Agenda
Hearing Examiner Meeting
Thursday, September 15, 2022
Richland City Hall ~ Council Chamber
625 Swift Boulevard
[Zoom](#) ~ Public Telephone Access: (206) 337-9723 or (253) 215-8782
Meeting ID No. 872 2126 7401

S2022-102 Halara Hills Preliminary Plat

Pahlisch Homes LLC has filed a preliminary plat application to divide 59.29 +/- acres into eighty-two (82) residential lots together with eight (8) tracts (open-space and stormwater runoff control). The neighborhood is to be known as the plat of Halara Hills. Access will be provided with the extension of Strawberry Lane into the site that will tee into a loop road formed by new roads: Lamont Street and Redtail Loop.

Figure 9. Fire disturbed shrubsteppe.

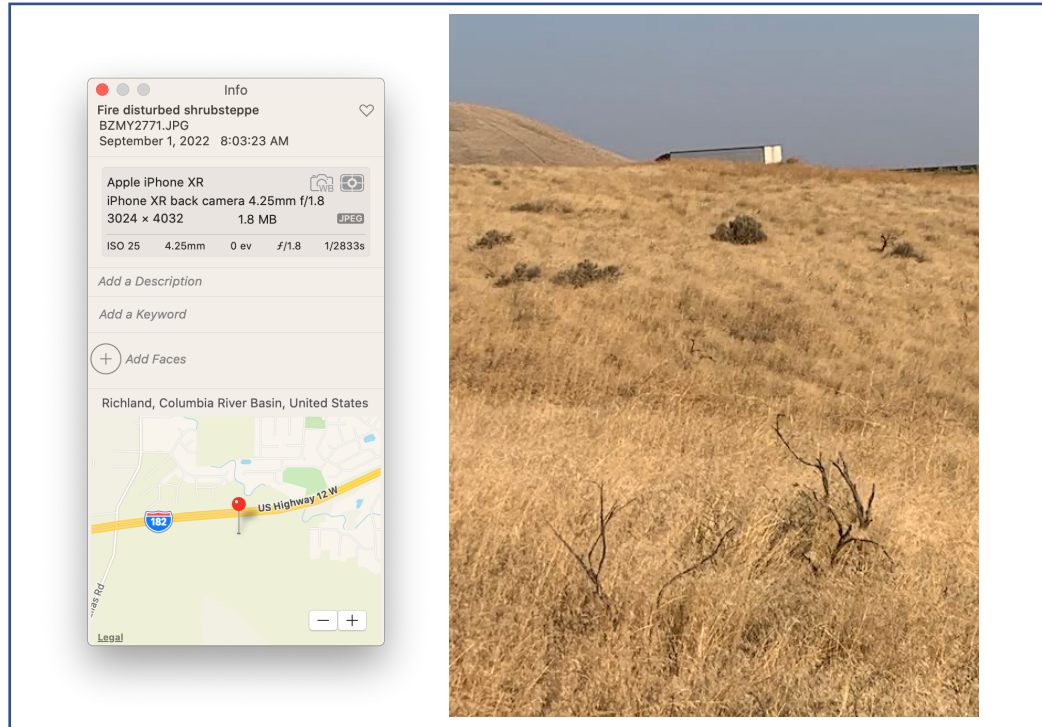
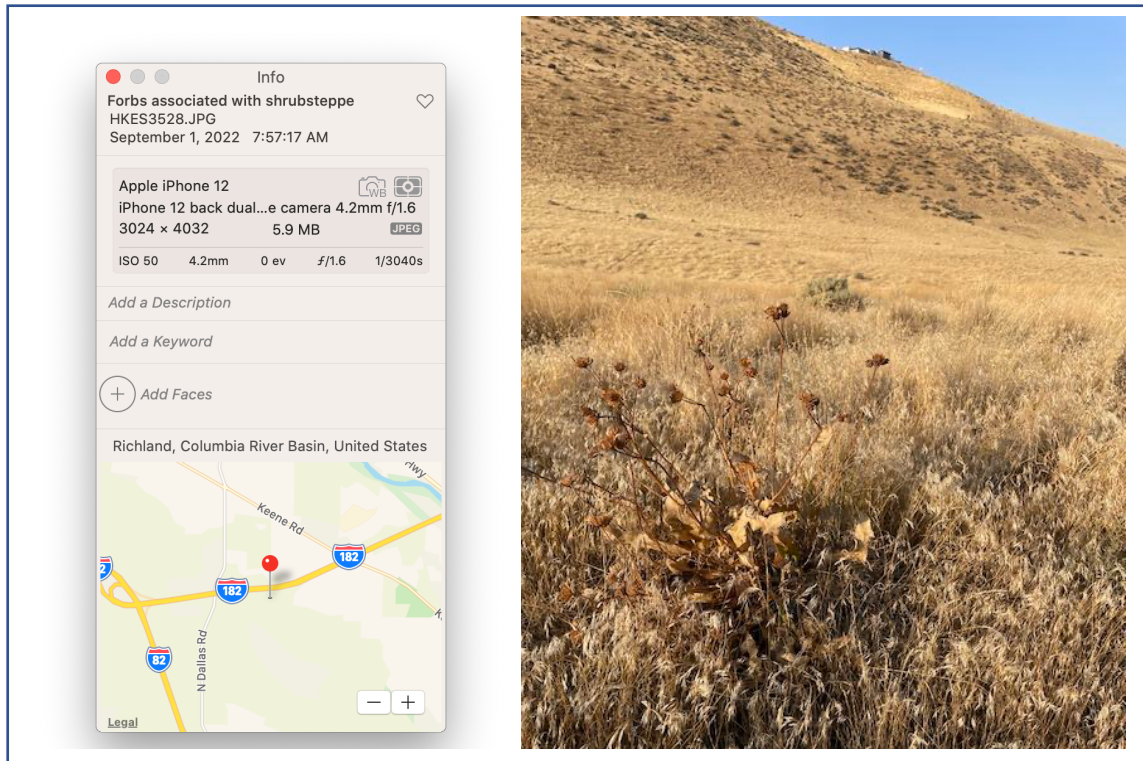
In a survey we conducted on September 1, 2022, we found additional evidence that the project site contains fire-disturbed shrubsteppe outside of areas described as shrubsteppe in the *Habitat Report*. Figure 9 and Figure 10 show remnants of burnt sage in this area and Figure 11 shows healthy shrubsteppe forbs.

Figure 12. Historical Imagery of Site, Mid-1990s, Google Earth, showing Shrubsteppe.

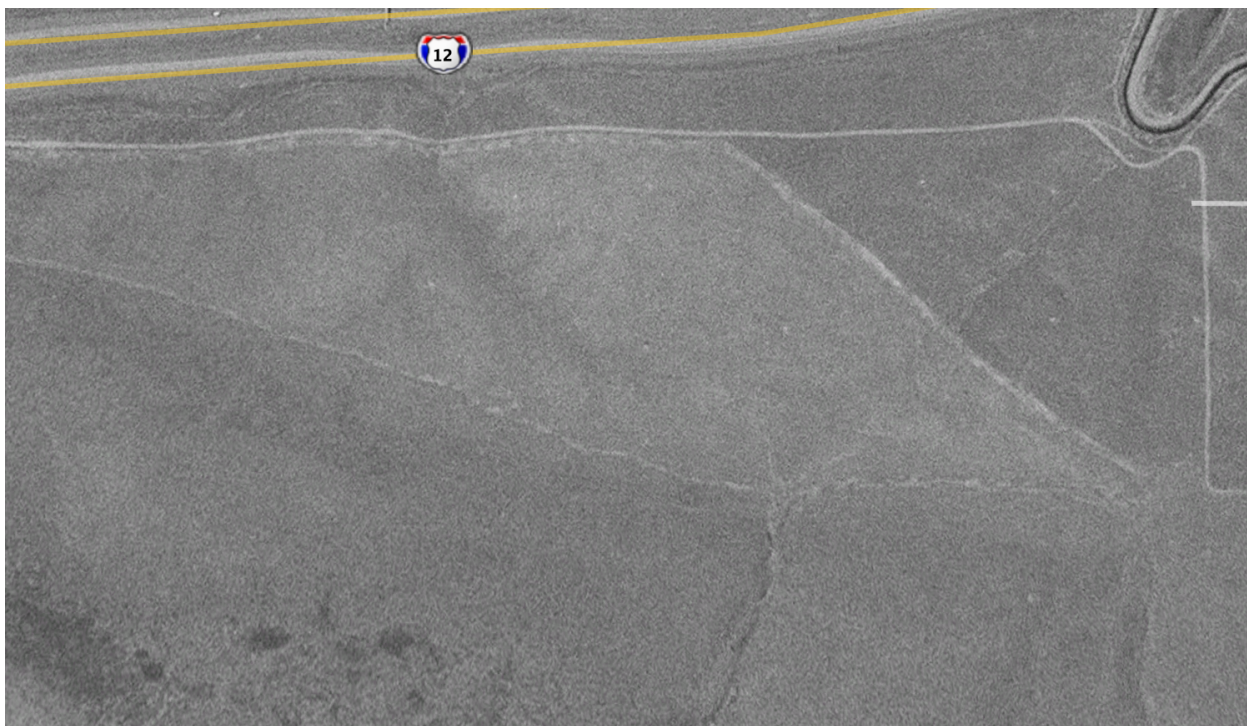
Imagery from the mid 1990s indicates high quality shrubsteppe in and adjacent to the site area; this can be compared with imagery of pasture-land from the 1990's and with areas known to be quality shrubsteppe at that time (Figure 12, Figure 13, and Figure 14). This indicates there was a fire in the early 2000's and that the site area is recovering shrubsteppe. Since Columbia Basin shrubsteppe takes about 20 years to recover from fire and fill in from a lower intensity burn³², the growth height of the sagebrush on much of the site corresponds with healthy recovering shrubsteppe priority shrubsteppe.
